9 March 2020

**RE: Western Sydney Aerotropolis**

I refer to the exhibition of various strategic planning documents concerning the Western Sydney Aerotropolis, including the Draft Western Sydney Aerotropolis Plan (Draft WSAP), Western Sydney Aerotropolis Discussion Paper on the proposed State Environmental Planning Policy (SEPP Discussion Paper) and Draft Western Sydney Aerotropolis Development Control Plan (Draft DCP) Phase 1.

**Map 1.** Extract from Figure 8-1 of Penrith Council 2019 South Creek Floodplain Risk Management Study.

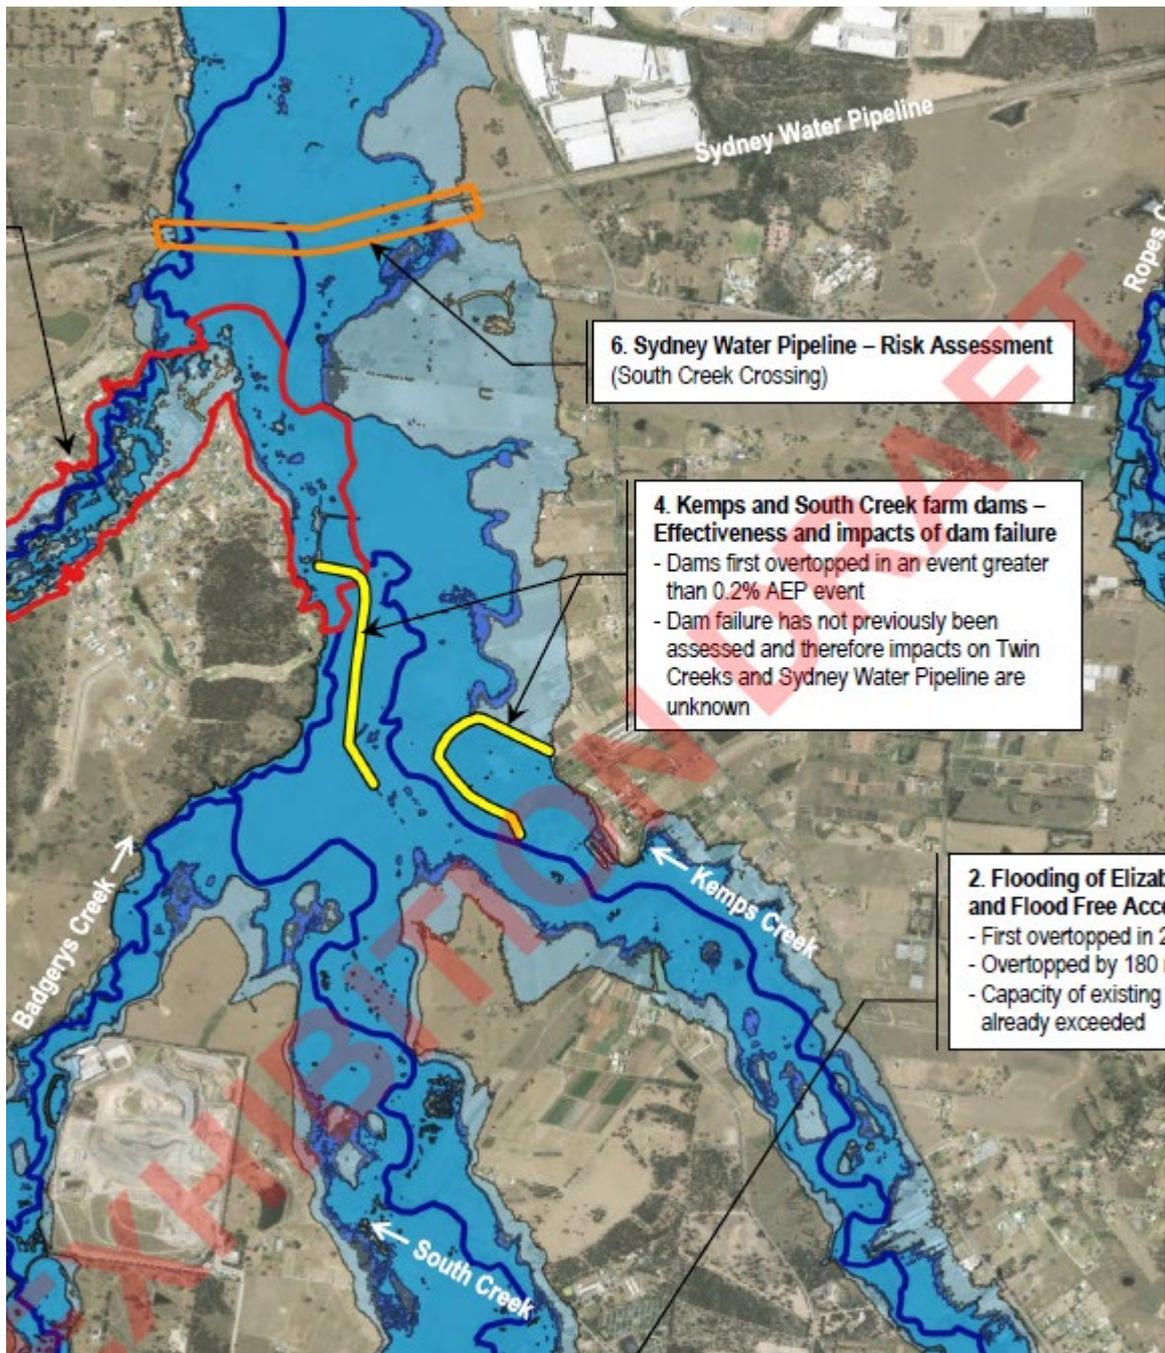
4. Two major farm dams in the adjoining Twin Creeks area have not been assessed for their risk of dam failure even under existing land uses (see Callout-Box 4 of Figure 8-1 of the Penrith Council 2019 South Creek Floodplain Risk Management Study, extract provided in Map 1 attached). The South Creek Floodplain Management Study indicated that these dams first overtopped in a greater than 0.2% AEP Event. Any increase in stormwater runoff arising from the Aerotropolis has the propensity to exacerbate the risk of these dams collapsing. The risk of these dams collapsing needs to be included in a stormwater and flood-risk management study suggested above, and based on the proposed land uses.
